Subject: Indian Point 3 Nuclear Power Plant  
Docket No. 50-286  
**Response to Request for Additional Information  
Concerning Proposed Technical Specification Changes  
For a 100% Helium Release from the Boron Coating of the Integral  
Fuel Burnable Absorber Rods and a Reduction of Maximum  
Permissible Reactor Coolant System Average Temperature**

**RESPONSE TO REQUEST FOR ADDITIONAL INFORMATION  
REGARDING PROPOSED CHANGES TO TECHNICAL SPECIFICATIONS FOR A 100%  
HELIUM RELEASE FROM THE BORON COATING OF THE INTEGRAL FUEL BURNABLE  
ABSORBER RODS AND A REDUCTION OF MAXIMUM PERMISSIBLE REACTOR COOLANT  
SYSTEM AVERAGE TEMPERATURE**

**SECL-96-046**  
**IFBA HELIUM RELEASE EVALUATION FOR CYCLE 9 RESTART**

Figure 2.1-1

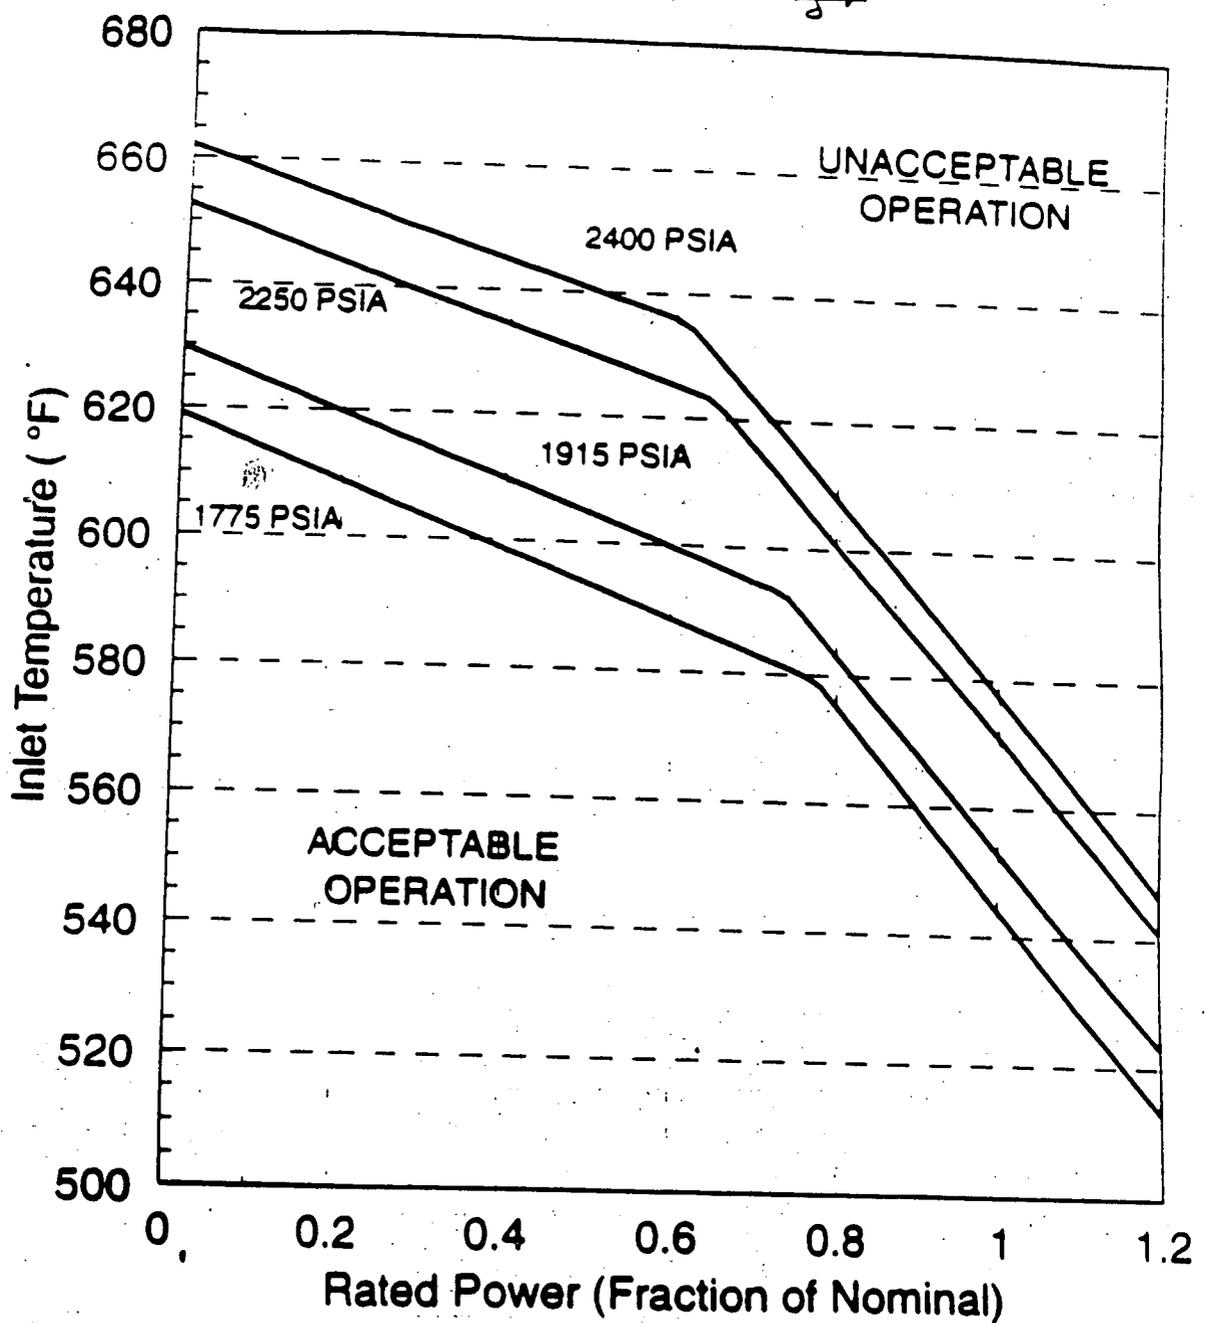
For Cycle 9 burnups beyond 14,000 MWD/MTU, this evaluation requires increasing the minimum measured flow to 385,400 gpm (see attached mark-ups).

Based on a Reactor Coolant Flow of greater than or equal to 385400 gpm
